Meeting of: BUSINESS PARK NORTH COMMITTEE OF THE CITY OF STOUGHTON

- 1. Call to Order
- 2. Elect Chair
- 3. Elect Vice-Chair
- 4. Consider approval on the BPN Committee Minutes of April 13, 2020.
- 5. Request by Edward and Patricia Bierer of Stellar Services for approval of a building addition at 301 Business Park Circle.
 - Recommendation to Plan Commission
- 6. Future agenda items.
- 7. Adjournment.

I have completed a final review of the proposed building addition/site plan for Stellar Services, LLC., 301 Business Park Circle. This item is planned to be on the Plan Commission and Business Park North agendas for May 11, 2020 of which you will receive notice. This project is also subject to the Business Park North Covenants as outlined below. As noted, additional information may be required to be provided or shown on the plan.

Landscape Plan

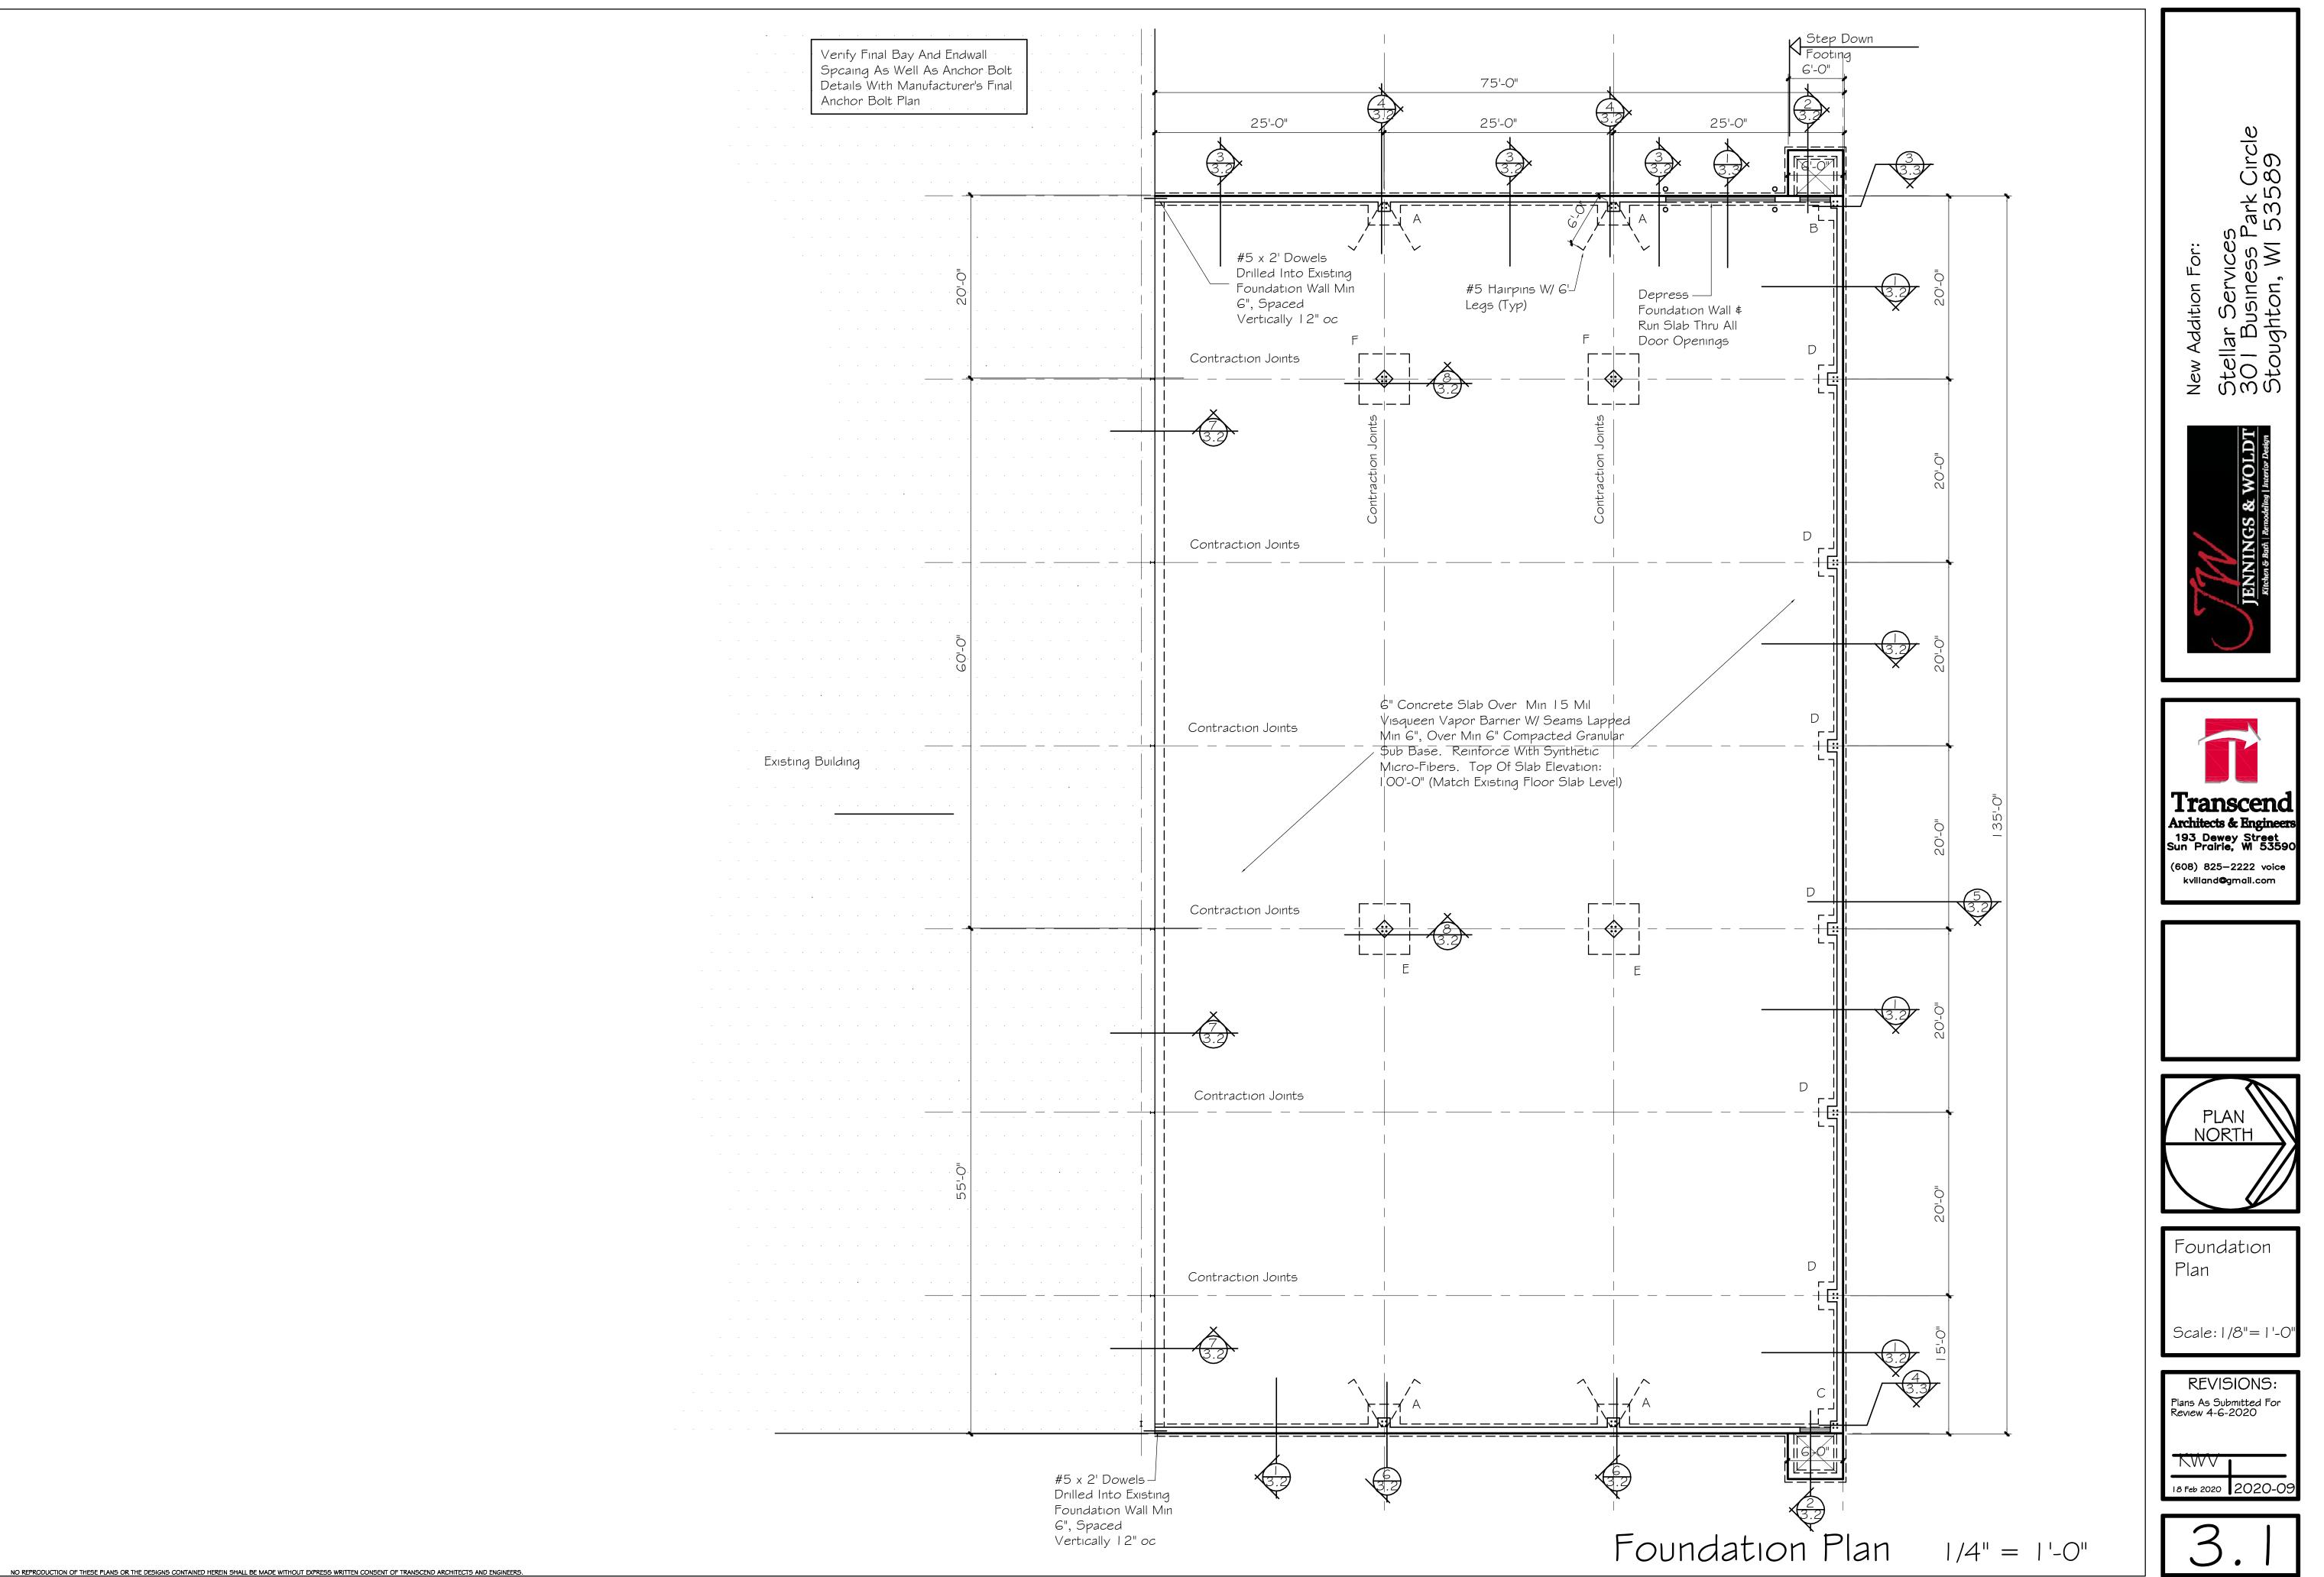
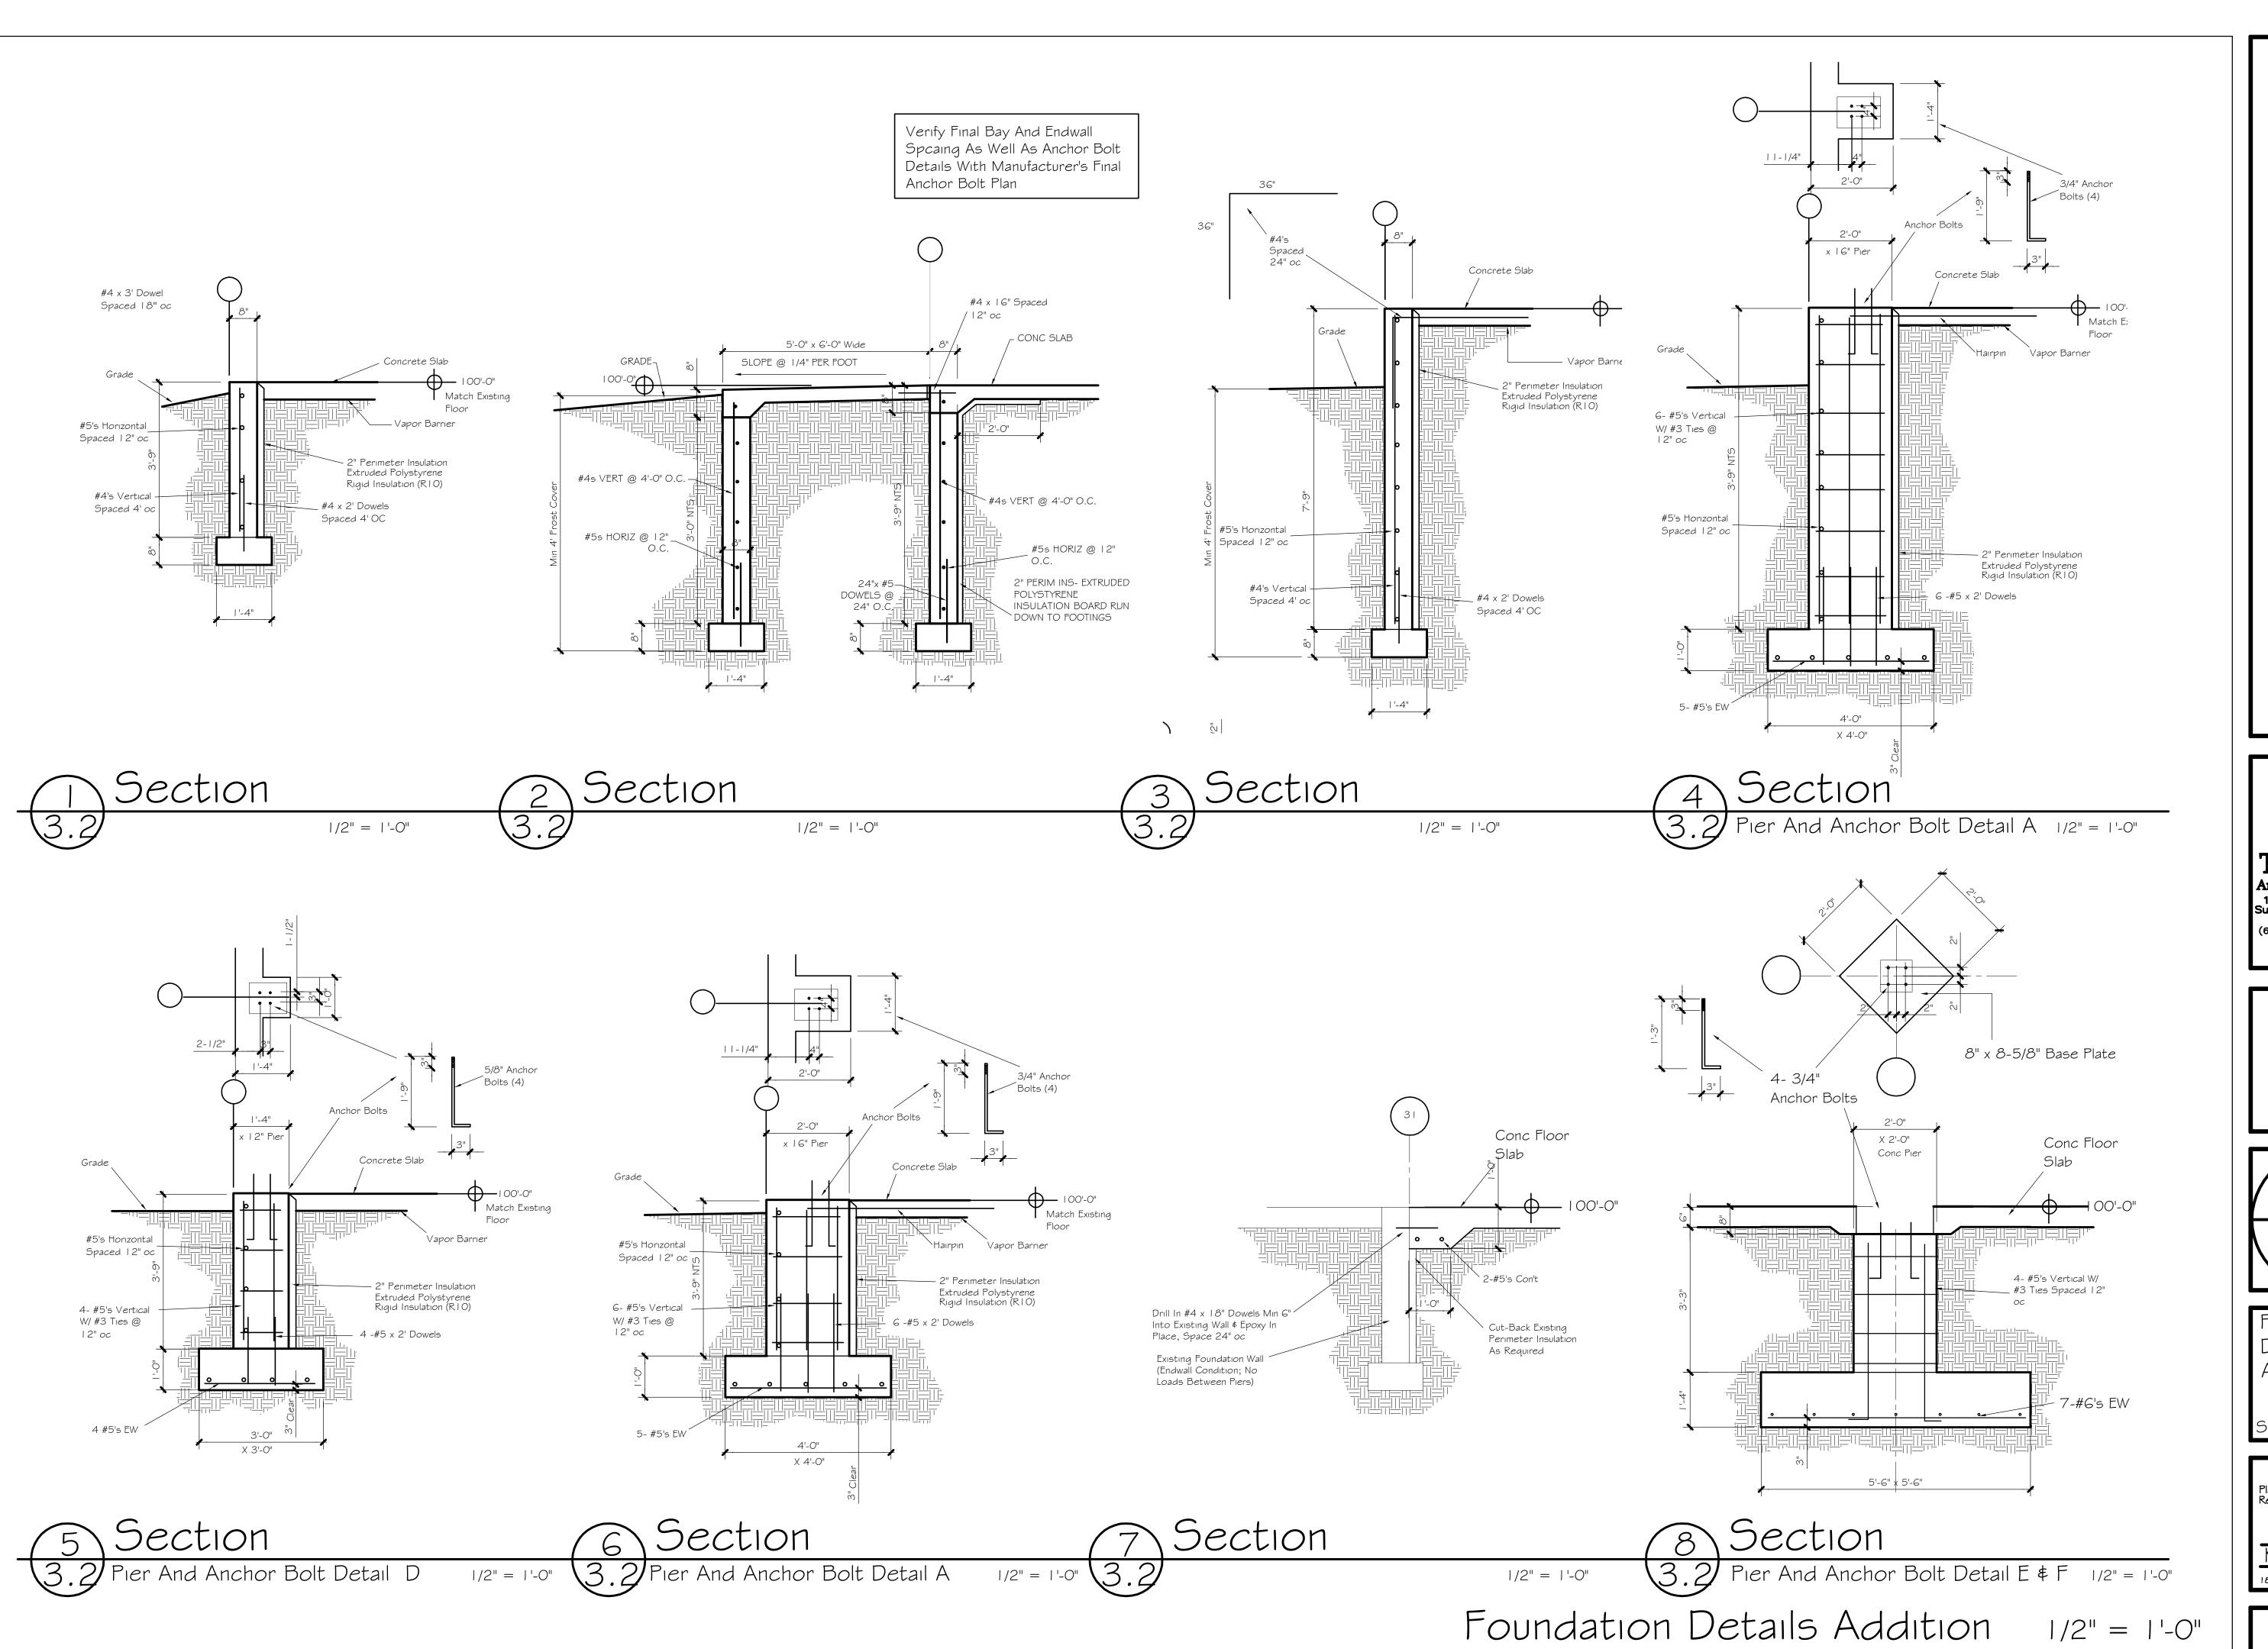
- Building foundations: 40 points of landscaping are required per 100 feet of foundation perimeter. 435 feet of foundation requires 174 points of landscaping which is required to be planted within 10 feet of the building foundations. Climax and tall trees cannot be used to meet this requirement.

- Developed Lots: 10 points of landscaping are required per 1,000 square feet of building footprint. 10,125 square feet of building requires 102 landscaping points.

The provided landscaping plan takes into account the entire building including the addition.
